REVISED RESPONSE TO REQUEST FOR ADDITIONAL INFORMATION

APR1400 Design Certification

RAI No.: 475-8596
SRP Section: 10.04.08 – Steam Generator Blowdown System
Application Section: 10.4.8
Date of RAI Issue: 05/04/2016

Question No. 10.04.08-6

Figure 2.7.1.8-1 Steam Generator Blowdown System

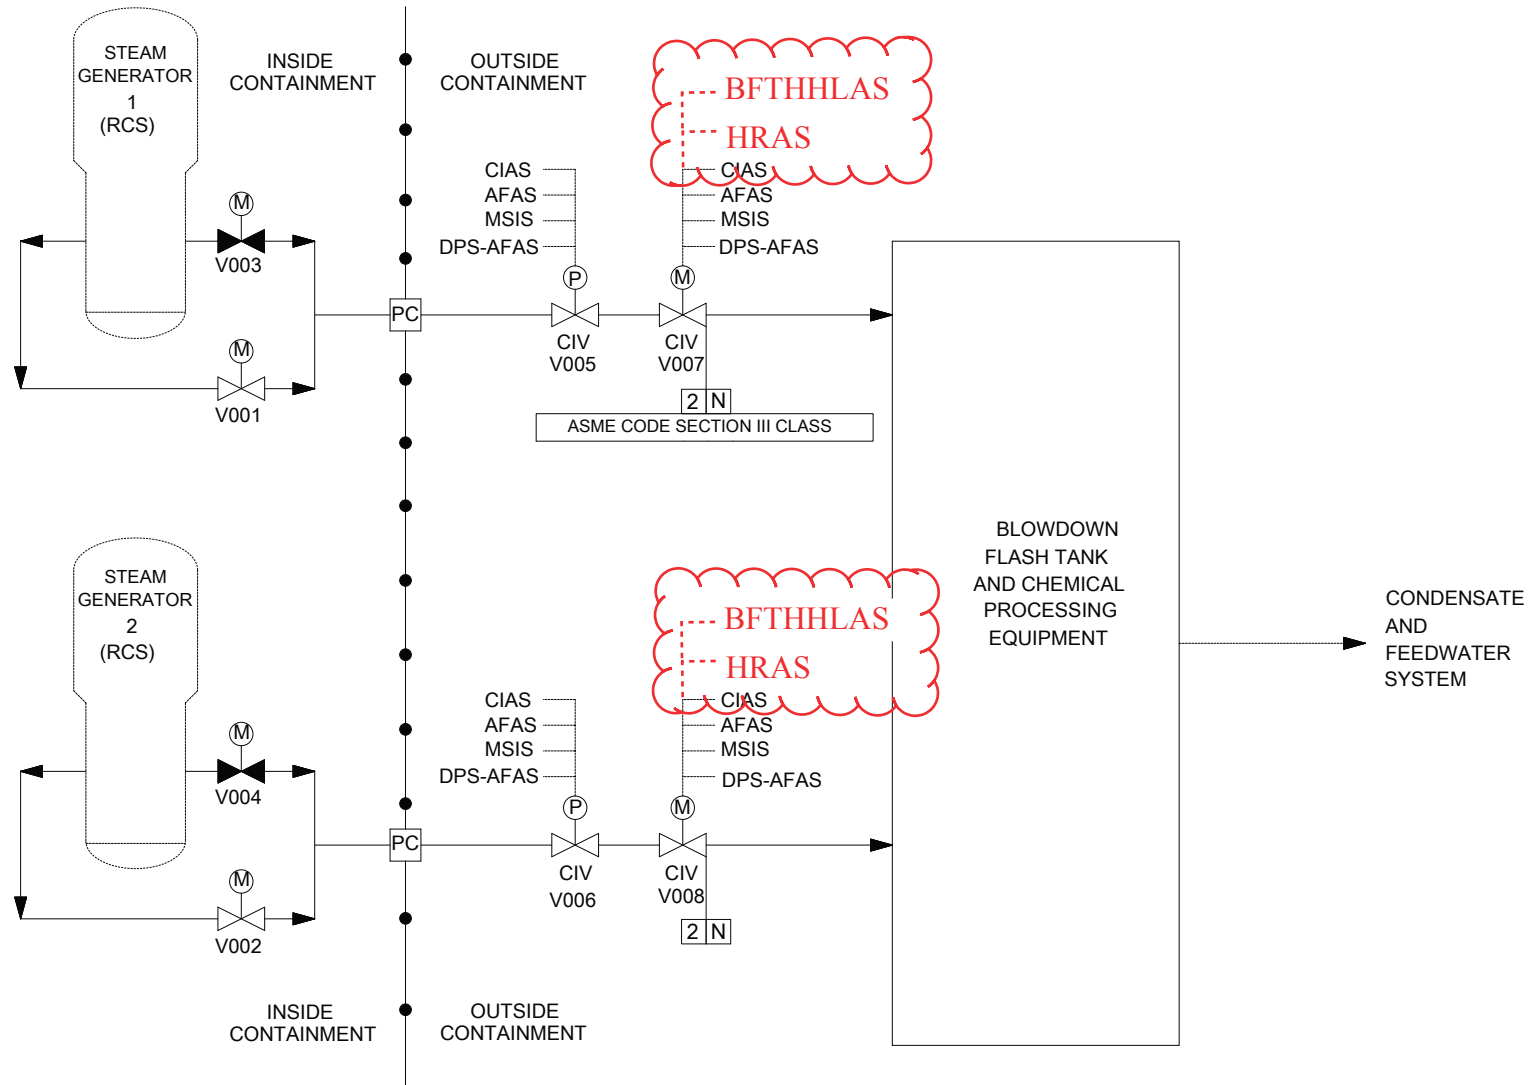
- a. The response proposes listing additional control signals in Tier 1 Table 2.7.1.8-1, but there is no corresponding change proposed for Tier 1 Figure 2.7.1.8-1. Since Figure 2.7.1.8-1 shows the control signals associated with containment isolation valves, provide your plans for revising Figure 2.7.1.8-1 or the basis for not revising it.
- b. The response indicates that Tier 2 Chapter 7 intentionally discusses the instrumentation and controls at a higher level and does not describe individual signals. The staff determined that for consistency and clarity, the signals that activate the containment isolation valves should be identified in Chapter 7, especially in the functional diagrams. Please discuss your plans to add this information to the FSAR.

- a. DCD Tier 1 Figure 2.7.1.8-1 and ACRONYM AND ABBREVIATION LIST will be revised to include the HRAS and the BFTHHLAS signals as indicated in the Attachment. And the signal lines in DCD Tier 2 Figure 10.4.8-1 will be revised to a dashed line as indicated in the Attachment. [In addition, the signal description in DCD Tier 2 Figure 10.4.8-1 will be corrected as indicated in the Attachment.](#)
- b. To activate the containment isolation valves (CIVs), following signals are used:
 1. ESFAS (e.g., SIAS, CSAS, CIAS, MSIS, and AFAS) and DPS (e.g., DPS-AFAS) signals

For example, steam generator blowdown system CIVs 005, 006, 007, and 008 in Figure 2.7.1.8-1 of DCD Tier 1 are actuated by the CIAS, AFAS, MSIS, and DPS-AFAS. However, those CIVs are not related with the SIAS and CSAS.
